PCI-SIG ENGINEERING CHANGE NOTICE

TITLE:	Async Hot-Plug Updates
DATE:	Nov 29, 2018
AFFECTED DOCUMENT:	PCIe 4.0 Base Specification
SPONSORS:	Joe Cowan; Hewlett Packard Enterprise Austin Bolen; Dell EMC Dave Harriman; Intel Corporation

Figure 2-fl: ERR COR Message

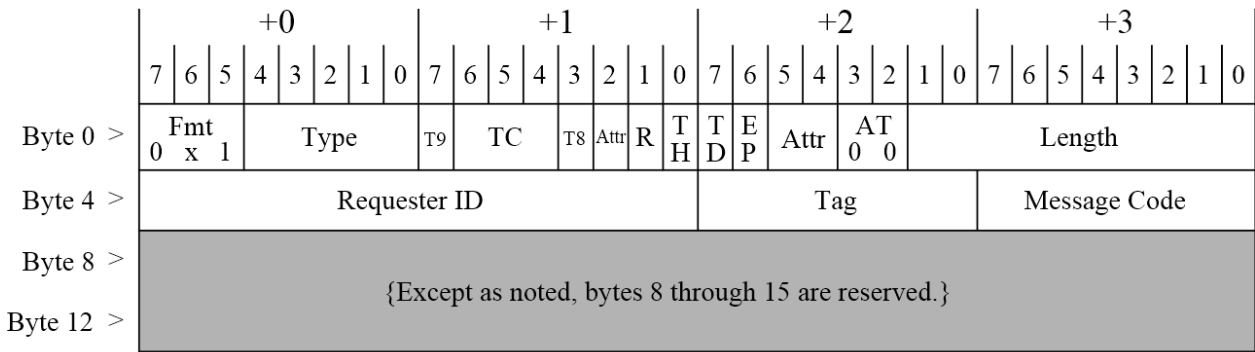
- ☐ ERR COR Messages have an ERR COR Subclass (ECS) field in the Message header that enables different subclasses to be distinguished from each other. See Figure 2-f1. ERR NONFATAL and ERR FATAL Messages do not have the ECS field.

Note to Editor: Please create a new figure by leveraging the preceding existing figure to add a 2-bit ECS field in bits 7:6 of byte 8, and indicating the remaining bits as Reserved. Also indicate a Fmt field value of 001, a Type field value of 1000, a TC field value of 000, a TH bit indication of R, an Attr indication of R R, a Length field indication of Reserved, and a Message Code value of 0011 0000.

Figure 6-3: Pseudo Logic Diagram for [Selected](#) Error Message Control [and Status Bits](#)

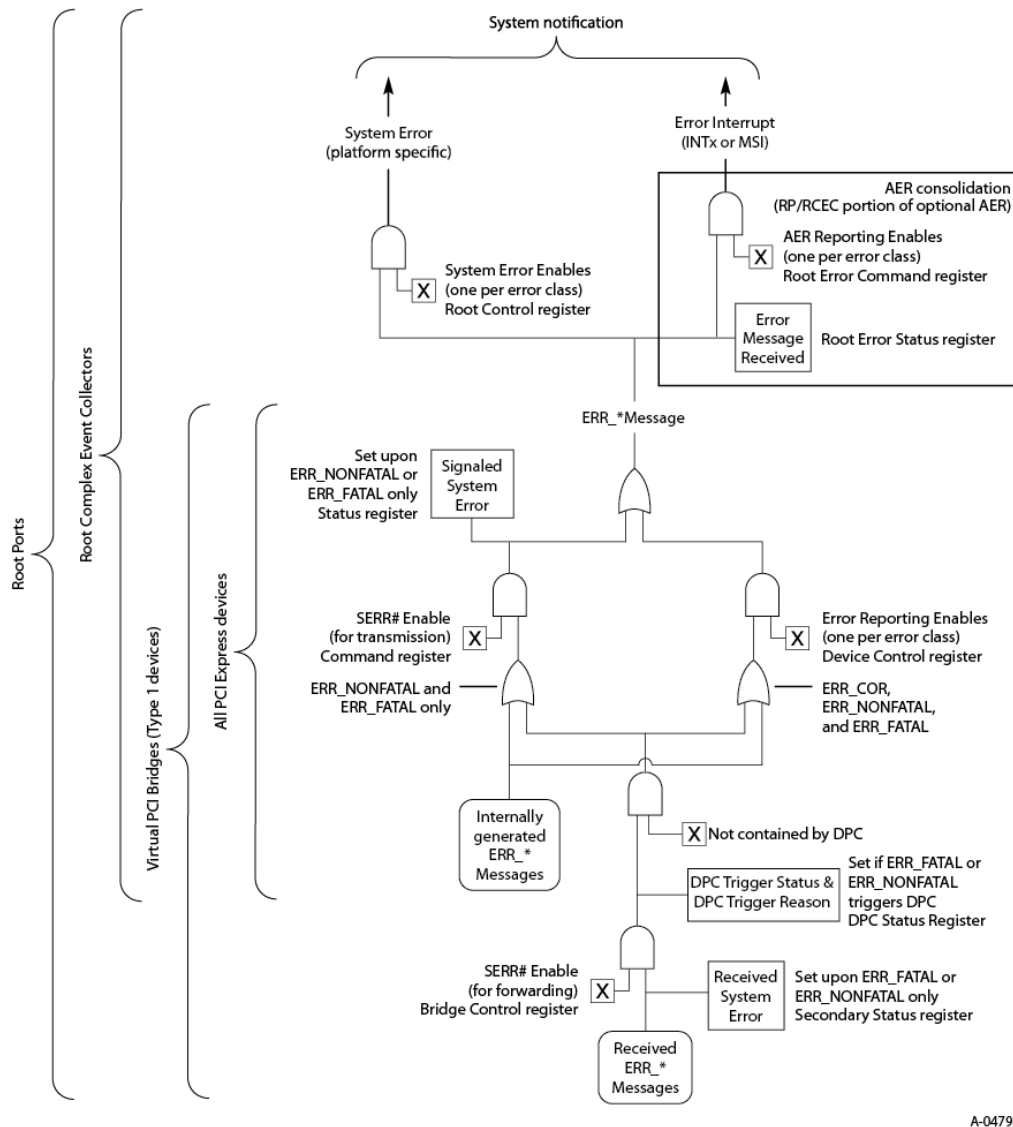
Error Messages have a complex set of associated control and status bits. Figure 6-3 provides a [conceptual high-level](#) summary in the form of a pseudo logic diagram for how error Messages are generated, logged, forwarded, and ultimately notified to the system. Not all [control and logged](#) status bits are shown. The logic gates shown in this diagram are intended for conveying general concepts, and not for direct implementation.

Figure 7-25: Device Capabilities Register

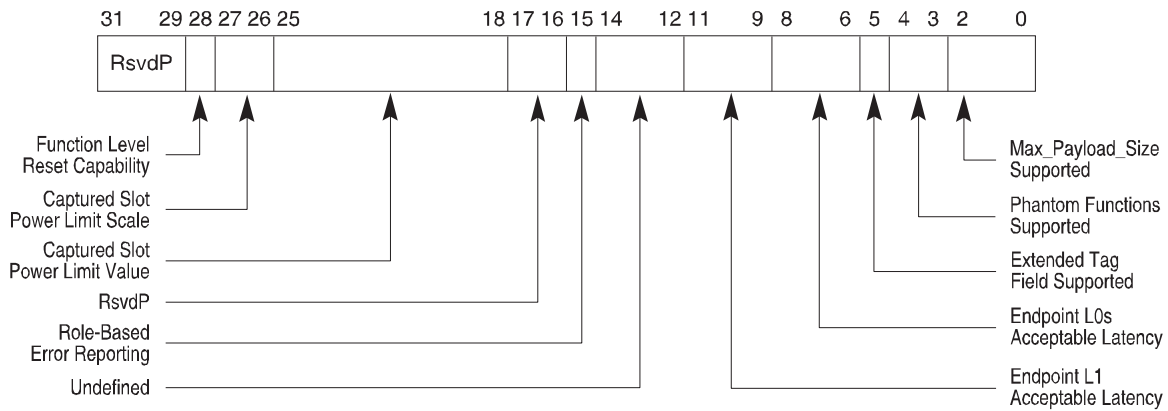
Note to Editor: Please update the preceding figure with the bit defined in the table below.

Bit Location	Register Description	Attributes
...
16	<p>ERR_COR Subclass Capable – When Set, this bit indicates that the Function supports the ERR_COR Subclass field in ERR_COR Messages, allowing different subclasses to be distinguished. See Section 2.2.8.3.</p> <p>Downstream Ports that implement the System Firmware Intermediary (SFI) capability must Set this bit. Downstream Ports that implement Downstream Port Containment (DPC) are strongly encouraged to Set this bit.</p>	RO

Figure 7-30: Slot Control Register

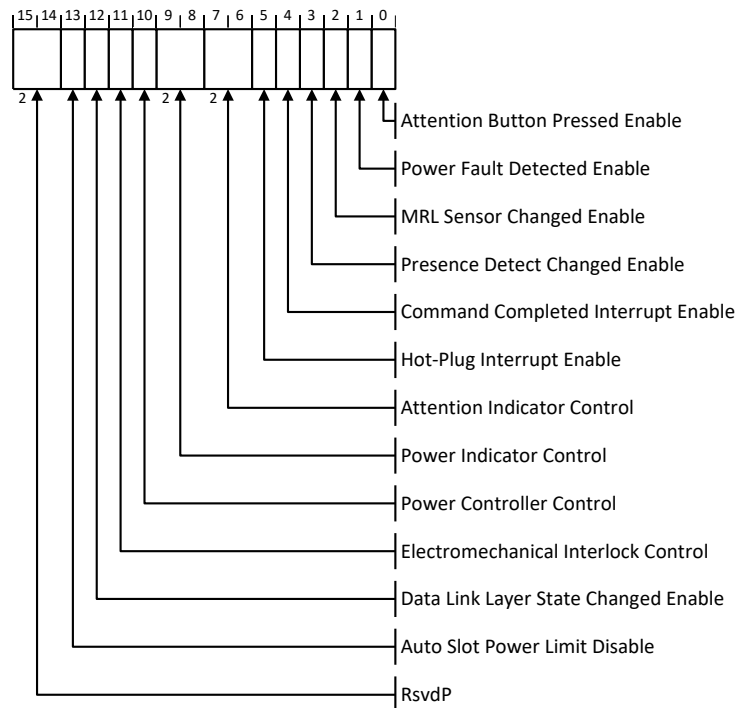
Note to Editor: Please update the preceding figure with the bit defined in the table below.

Bit Location	Register Description	Attributes
...
14	<p>In-Band PD Disable – When Set, this bit disables the in-band presence detect mechanism from affecting the Presence Detect State bit, allowing that bit to report out-of-band presence detect exclusively. Otherwise, the Presence Detect State bit reflects the logical OR of the in-band and out-of-band presence detect mechanisms.</p> <p>In addition, the In-Band PD Disable bit governs the Component Presence state for the Downstream Component Presence field in the Link Status 2 register. See Section 7.5.3.20.</p> <p>This bit must be implemented if the In-Band PD Disable Supported bit is 1b. Otherwise, this bit must be hardwired to 0b.</p> <p>Default value of this bit is 0b.</p>	RW

Figure 7-117: Root Error Status Register

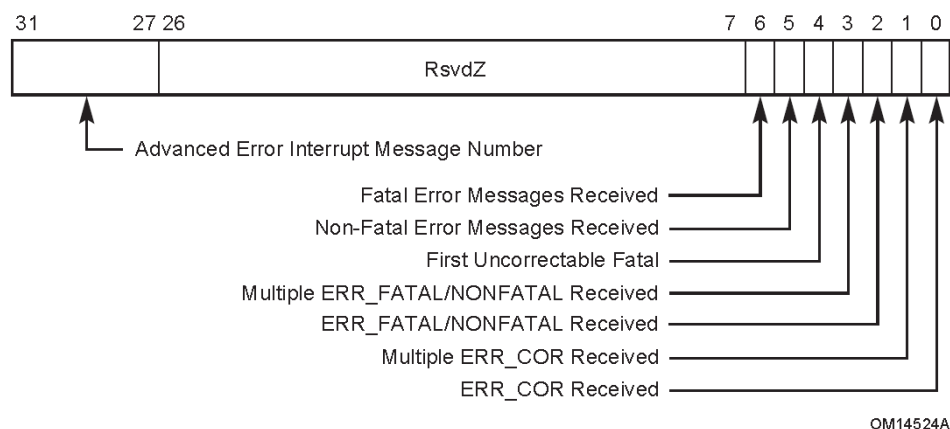
Note to Editor: Please update the preceding figure with the field defined in the table below.

Bit Location	Register Description	Attributes
...
8:7	<p>ERR_COR Subclass – If the Function is ERR_COR Subclass capable and the ERR_COR Received bit is not already Set, this field is loaded with the value of the ERR_COR Subclass field in the received ERR_COR Message. See Section 2.2.8.3. The value in this field is only valid when the ERR_COR Received bit is Set. If the Function is not ERR_COR Subclass capable, this field is Reserved.</p> <p>If the Function is ERR_COR Subclass capable and a SIG_SFW_ERR_COR Message is received, system firmware should be signaled using a system-specific mechanism.</p> <p>Default value of this field is 00b.</p>	ROS / RsvdZ

Figure 7-233: DPC Control Register

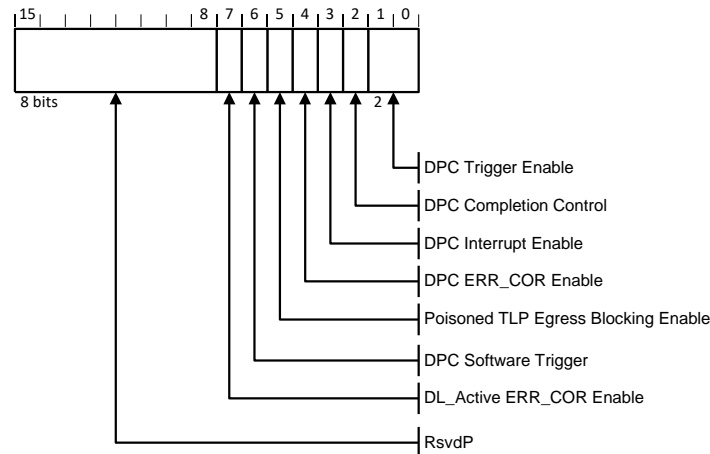
Note to Editor: Please update the preceding figure with the bit defined in the table below.

Bit Location	Register Description	Attributes
...
<u>8</u>	<p>DPC SIG_SFW Enable – This bit must be implemented if the ERR_COR Subclass Capable bit in the Device Capabilities register is Set; otherwise, it is permitted to be hardwired to 0b. If the ERR_COR Subclass Capable bit is Clear and software Sets this bit, the behavior is undefined.</p> <p>When Set, this bit enables sending an ERR_COR Message to indicate a DPC event that's been enabled for ERR_COR signaling. See Sections 6.2.10.2 and 6.2.10.5. This is an additional and alternative way to enable overall DPC ERR_COR signaling beyond the Correctable Error Reporting Enable bit in the Device Control register. This bit does not affect a Function's ability to send ERR_COR Messages other than the ECS SIG_SFW subclass. Default value of this bit is 0b.</p>	RW / RO

Figure 7-234: DPC Status Register

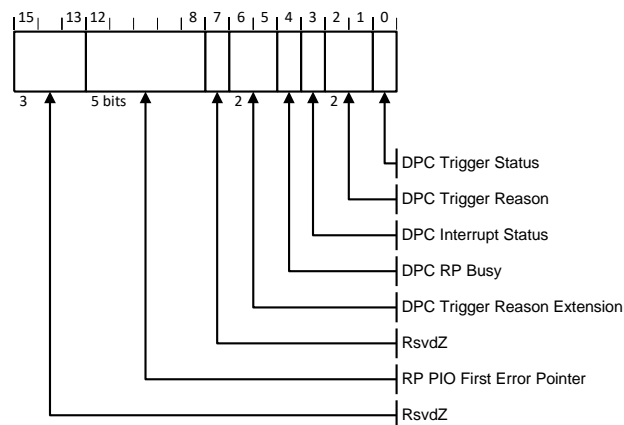
Note to Editor: Please update the preceding figure with the bit defined in the table below.

Bit Location	Register Description	Attributes
...
13	DPC SIG SFW Status – If the Function supports ERR_COR Subclass capability , this bit must be implemented; otherwise, it must be hardwired to 0b. If implemented, this bit is Set when a SIG_SFW_ERR_COR Message is sent to signal a DPC event. See Sections 6.2.10.2 and 6.2.10.5 . Default value of this bit is 0b.	RW1CS / RsvdZ
